MONTGOMERY COUNTY PLANNING DEPARTMENT
 THE MARYLAND-NATIONAL CAPITAL PARK AND PLANNING COMMISSION

MEMORANDUM

REVIEW TYPE: **Site Plan Review**
 CASE #: **820070210**
 PROJECT NAME: **R Holt Easley's Subdivision**
 APPLYING FOR: Approval of 9,226 square feet of building area that includes ground floor retail and second floor office space
 REVIEW BASIS: Div. 59-D-3 of Montgomery County Zoning Ordinance
 ZONE: CBD-1 and Fenton Village Overlay Zone
 LOCATION: On Fenton Street, 200 feet South of Thayer Avenue
 MASTER PLAN: Silver Spring CBD Sector Plan
 APPLICANT: 8227 Fenton Street, LLC
 FILING DATE: April 16, 2007
 HEARING DATE: December 6, 2007

I. Pedestrian safety and circulation along the alley

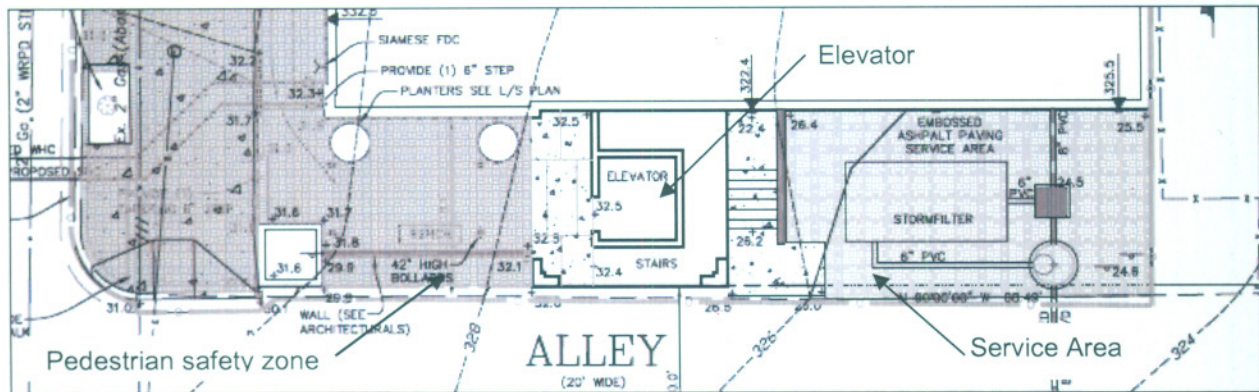
The alley adjacent to the southern property edge provides a mid-block connection between Fenton Street and the residential neighborhood to the East. Currently, the alley has relatively low vehicular traffic. However, a recently approved project, 814 Thayer, will use the alley as the sole access for its 36-space parking garage located below the building, significantly increasing daily vehicular traffic on this alley. Staff is concerned that this additional vehicular traffic may impact pedestrian safety and circulation on the alley.

Originally, Staff had requested pedestrian access along the public alley in the form of a 5-foot wide path within the property line. This path would be extended beyond the property line as part of the redevelopment of adjacent properties. However for a variety of reasons mostly associated with the limited size of the property and architectural constraints, this option was deemed infeasible.

The revised site plan addresses concerns of pedestrian safety on the alley by creating a pedestrian safety zone. As proposed, most of the southern property edge is now open and flush with the alley. Only the section where the elevator and stairway are located lacks any setback for pedestrian refuge. Since this area represents only a total length of 20 feet and is immediately

adjacent to areas where pedestrians can take refuge from vehicular traffic, it appears to be acceptable.

In response to Staff's concerns, the Applicant has revised the site plan to provide a pedestrian safety zone in the public use space that is flush with the alley. This safety zone is separated from the public use space by a retaining wall with railing that is recessed from the alley by 5 feet.

In spatial sequence from Fenton Street and along the alley, this plan proposes a planter flush with the grade that abuts the alley, followed by a recessed retaining wall with railing that delineates the pedestrian safety zone (20 feet total length), next to the elevator and stairwell that abuts the alley (20 feet total length), followed by a service area that is open and flush with the alley. As proposed, most of the southern boundary, with the exception of the elevator and stairway envelope is permeable for pedestrians, enabling them to avoid vehicular traffic on the alley.

II. Public use space

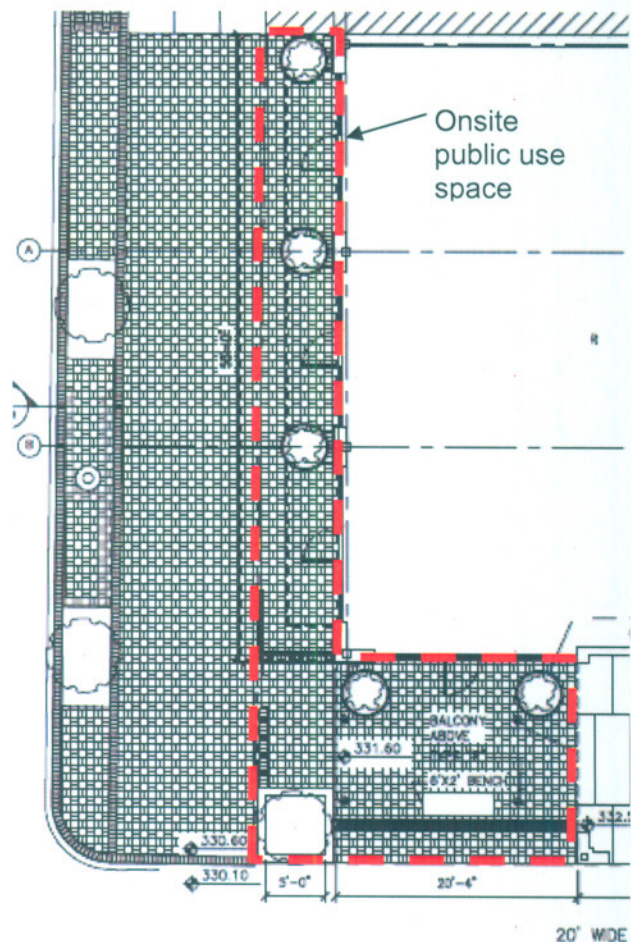
Public use space should be designed to make a meaningful contribution to the open space system in Fenton Village. Presently, 314 new residential units are pending or approved on and around Fenton Street, and other projects not yet submitted will add to that number in the near future. All development in Fenton Village should ensure that the proposed public use spaces will truly be perceived as part of the public realm, rather than as private spaces. Spaces should be interesting and inviting, thus enhancing the identity of Fenton Village.

Staff's initial recommendations were that the proposed public use space should consist of a distinct, consolidated space, rather than an extension or widening of the sidewalk in front of the proposed building. Staff preferred that the building setback from the public right-of-way be zero, thus consistent with the adjacent buildings, and that the public use space be consolidated on the side of the building.

This recommendation could not be accommodated due to constraints imposed by the building footprint, the building code, and the requirement for onsite public use space. In order to accommodate the 10 percent minimum requirement for onsite public use space differently than proposed, the building footprint and/or second floor access had to change. Yet, this building has been designed to provide three identical retail spaces, which limits changes to the footprint, and access to the second floor had to be a set distance from the internal stairwell. In order to better articulate the public use space in the front of the building and to activate the street, overhang canopies above each retail entrance are requested.

The site plan proposes an 'L-shaped' public use space that extends along the building façade and wraps around the southern edge of the building. The dedicated public use space in the front of the building is 6 feet wide and results in a greater building setback from the street. On the south side of the building the public use space provides seating and access to the elevator foyer. Large planter pots provided on the front and south side of the building act as a unifying element for the public use space.
